LONGHORN ARMY AMMUNITION PLANT KARNACK, TEXAS

ADMINISTRATIVE RECORD

***LONGHORN ARMY AMMUNITION PLANT
KARNACK, TEXAS
ADMINISTRATIVE RECORD – CHRONOLOGICAL INDEX***

FIGURE 3

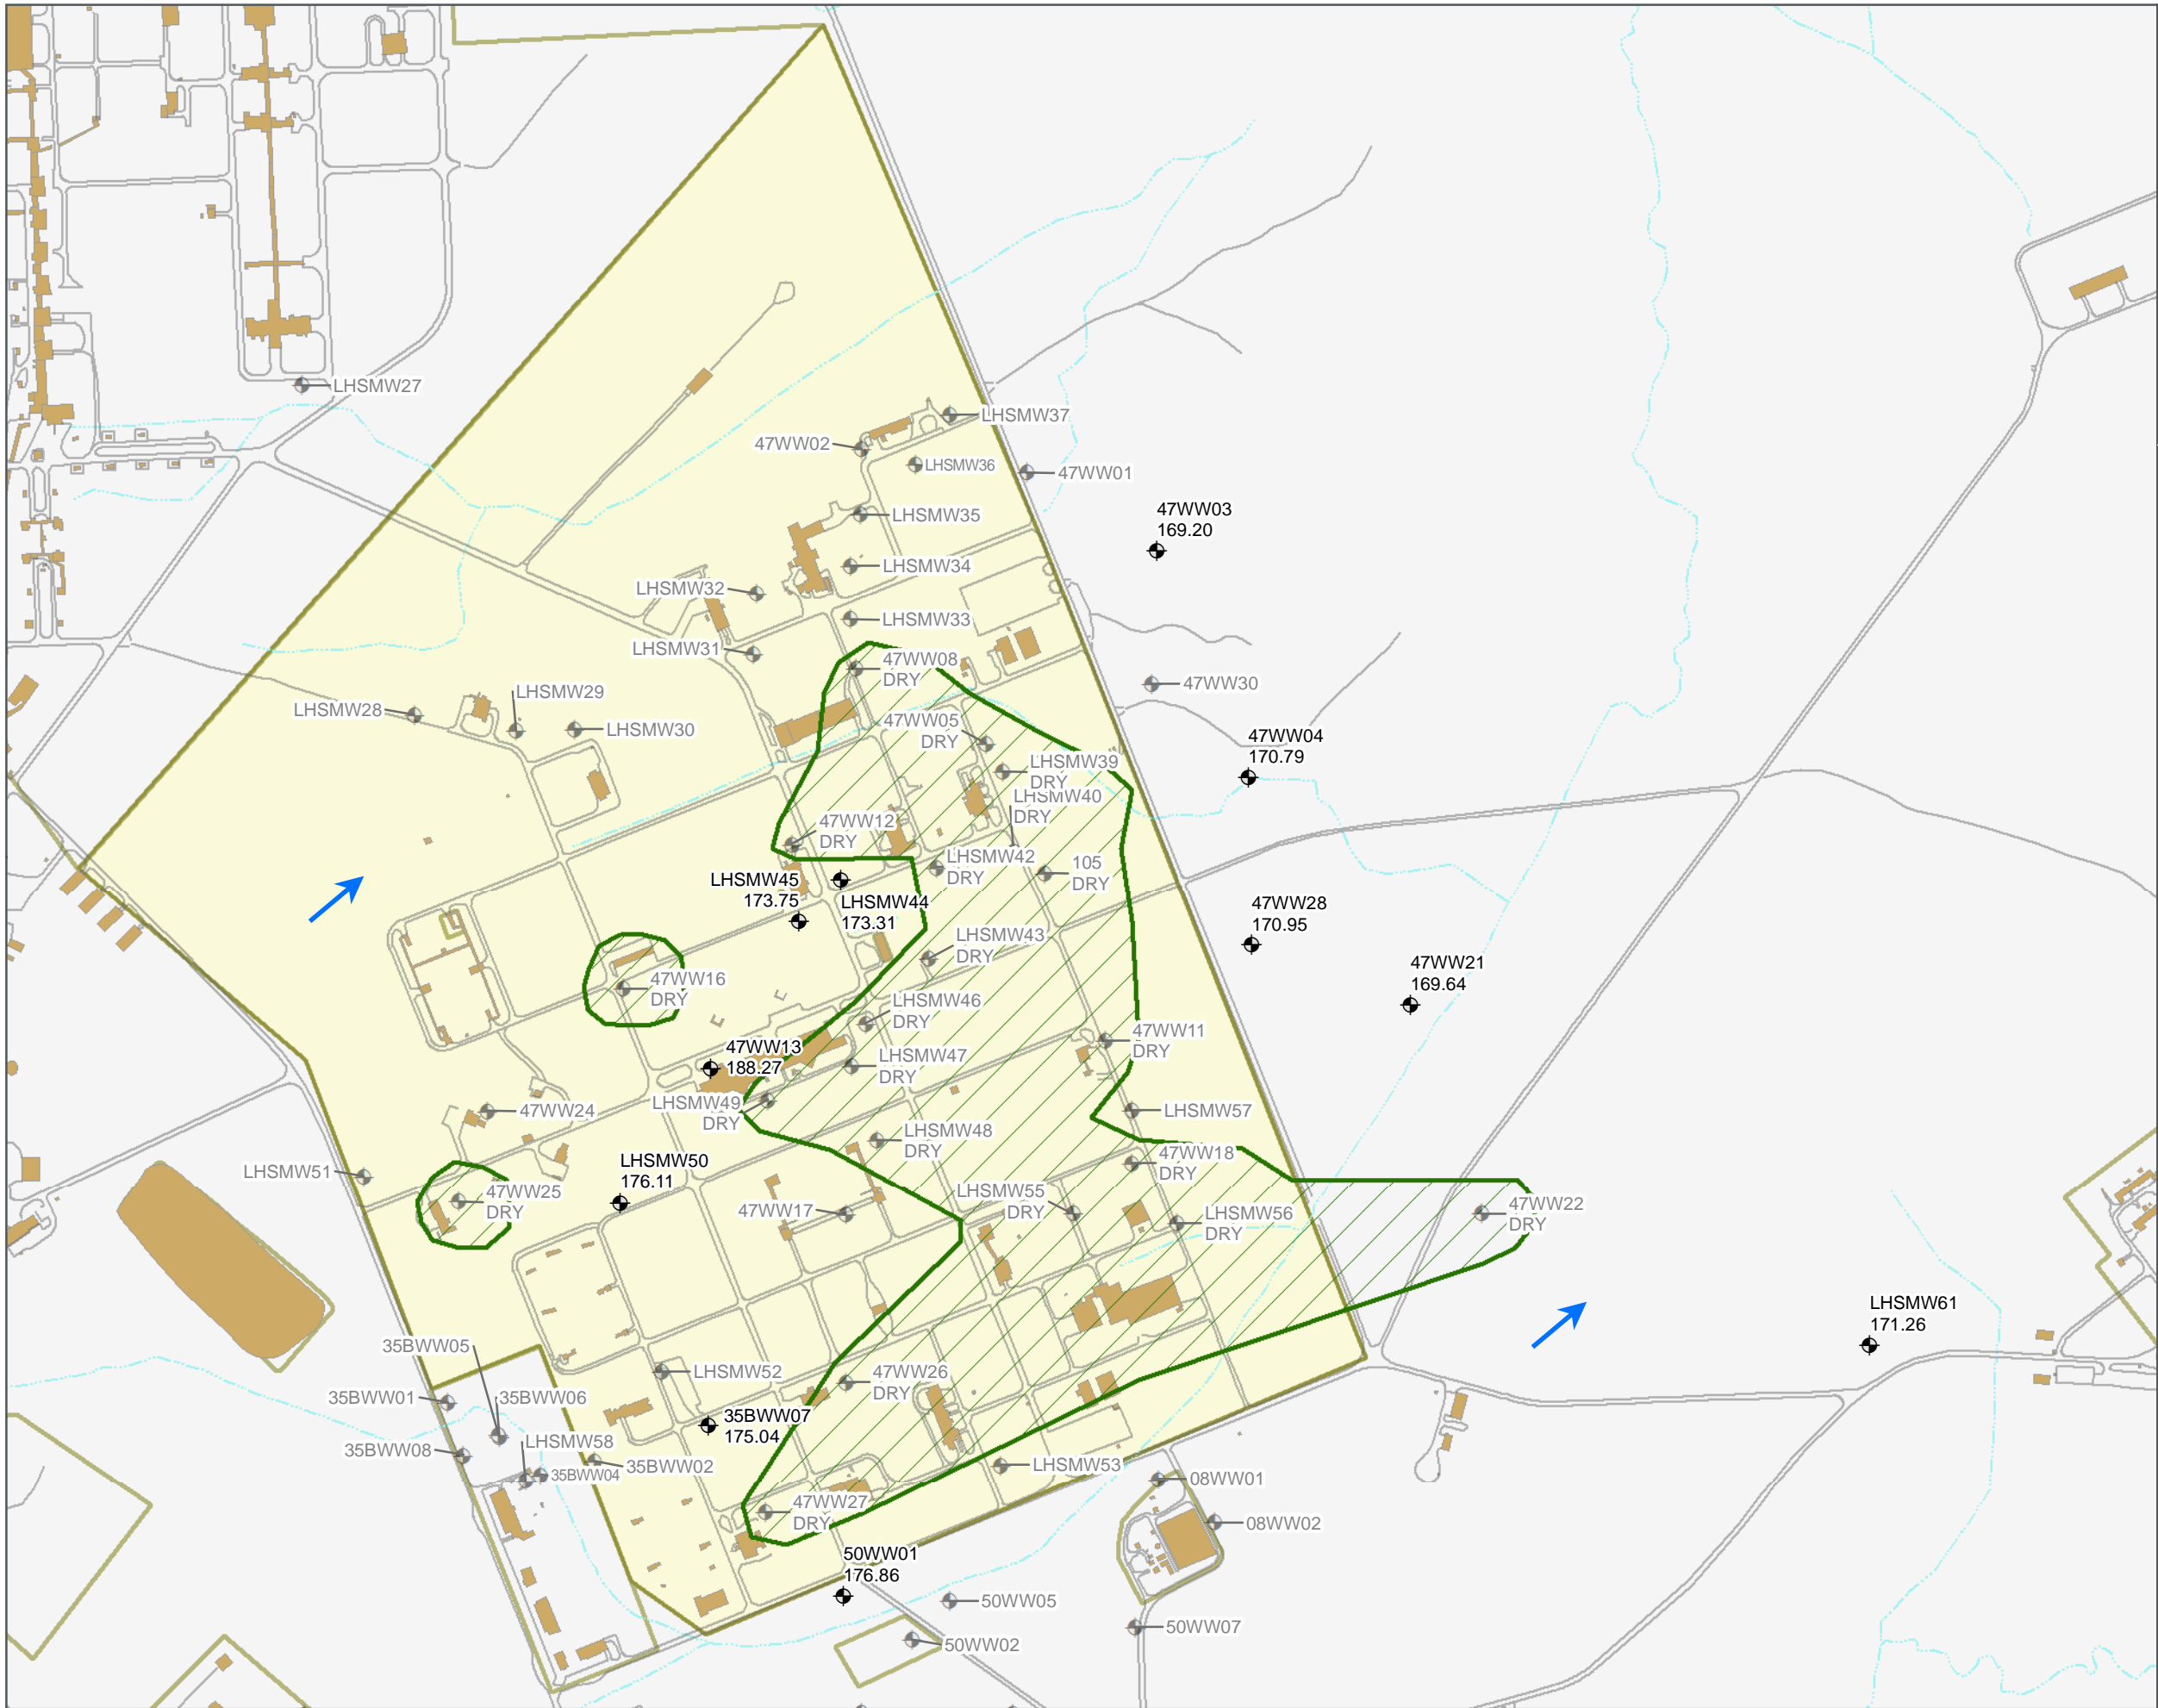
6	Figure 3		Description of the map indicates potentiometric contour, but there are no contours shown. With a large dry zone found, EPA is not sure that this is the best approach to depict flow direction. EPA recommends using a few directional arrows on the map towards the northeast.	C	A note will be added to the legend that due to a majority of shallow wells being dry, contours were not created. Two general groundwater flow direction arrows will be added to the map.

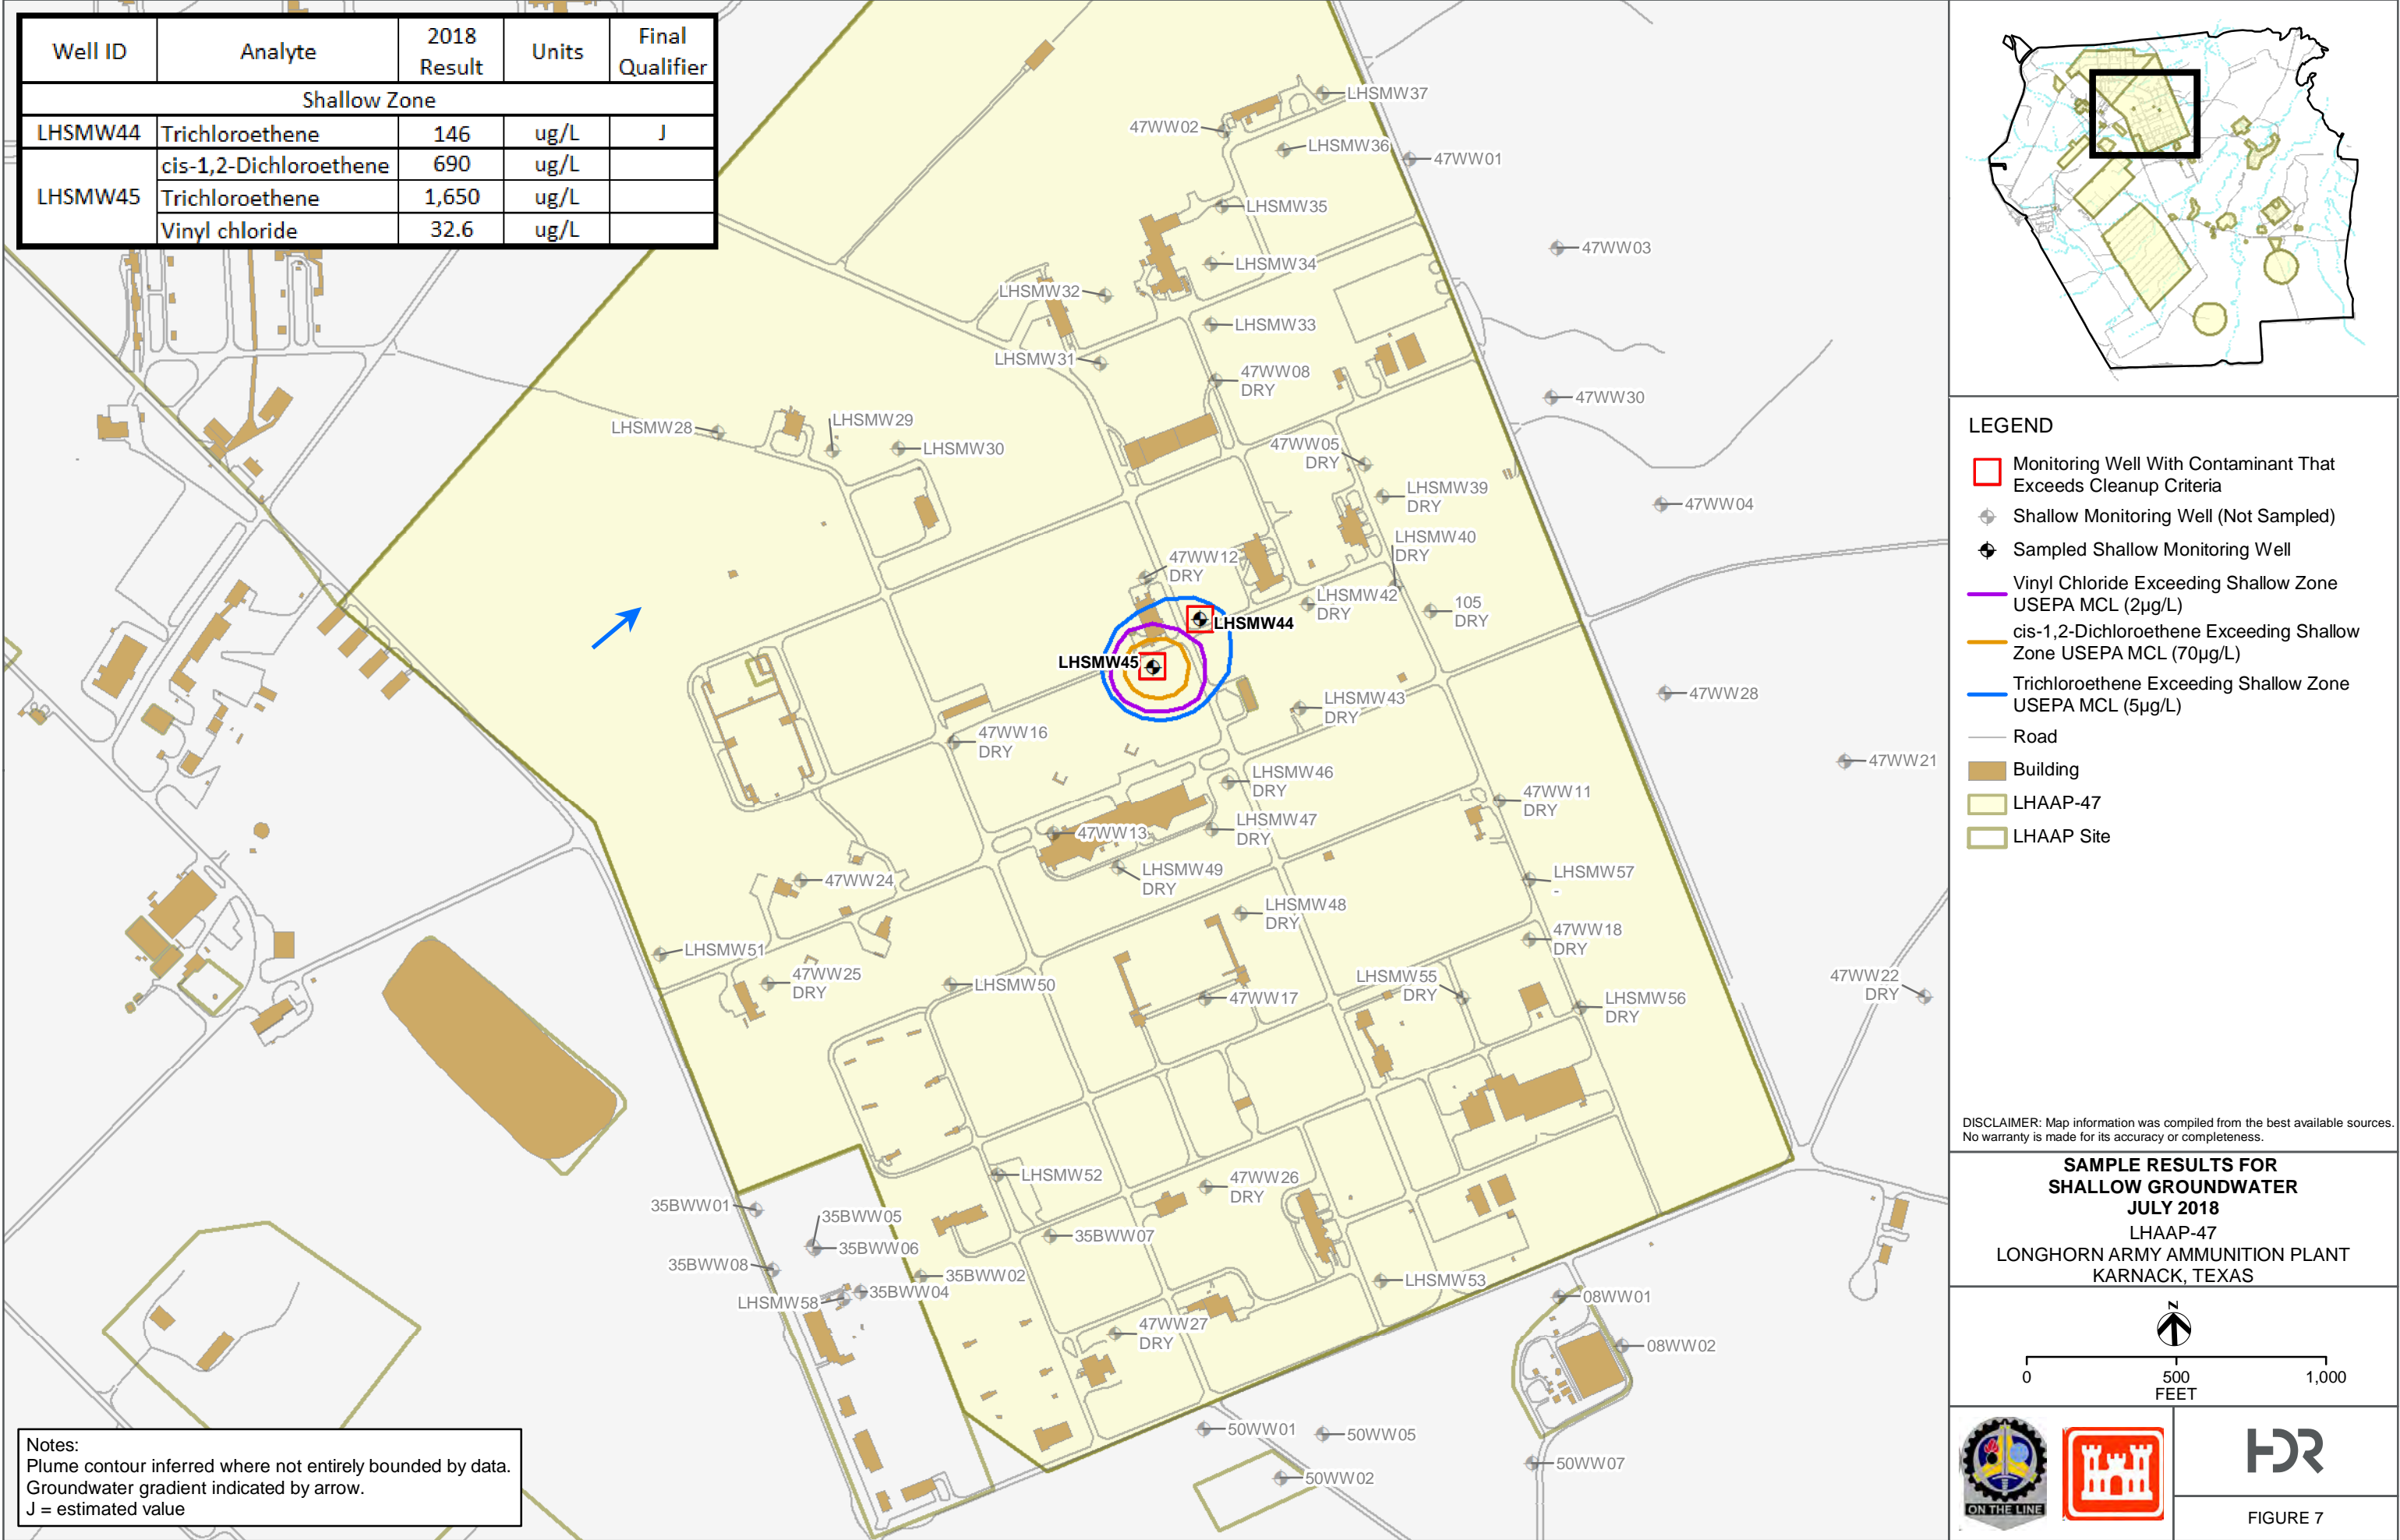
Number	Section/Page	Paragraph/ Line	Comment	C,D,E	Response	A,D
33	Figure 8		Please add the definitions for J/J+ to inset table. In additional, there are advantages of including a map that includes all the main VOCs, but in this case, would suggest breaking out the main ones like TCE into separate maps with concentration values listed by well instead of in table. The figures in this report are too busy and difficult to use. Very difficult to follow the text to the figure when looking at the plume designations. In addition, the explanation key says exceedances are in the shallow zone, should it be called the shallow/intermediate or intermediate? The Title of the figure is for the intermediate zone.	C/E	Qualifiers were added. The plumes are presented on a single map so the reader can reference the footprints of each contaminant by only having to review a single map. The plume maps are being enlarged to 11x17 format, which should make them more legible. Additionally, adding results next to each well was too difficult to eliminate overlap of data and well locations. This is why the results are presented in table format on the side of the figure. Figure titles were corrected as requested. Shallow/Intermediate references for new wells were updated to "Intermediate (Upper)".

Number	Section/Page	Paragraph/ Line	Comment	C,D,E	Response	A,D
45	Figure 8		The results on this map should be split into two separate maps, in other words, the two separate aquifer results. It is too busy and is difficult to interpret from only one map.	D	Replacement wells should be identified as representative of the upper intermediate zone aquifer, but should not be presented separately in the figures. The text will be revised to state that an “R” appended to a well name designates it as a replacement for a dry shallow zone well. The replacement wells were drilled to 40 feet and extended into the intermediate zone sand. The wells were completed in the intermediate sand but also included some clay separating the shallow and intermediate zones. Changing to an 11 x 17 page size and increasing the resolution of the figures will improve the legibility and utility of the figures.	
46	Page 4-3	Surface Water Samples	Have the surface water samples been taken (the soil boring and groundwater sampling were taken from July to September 2018)? The narrative mentions that surface water samples will be collected later due to dry conditions.	-	Surface water sampling is planned for early March.
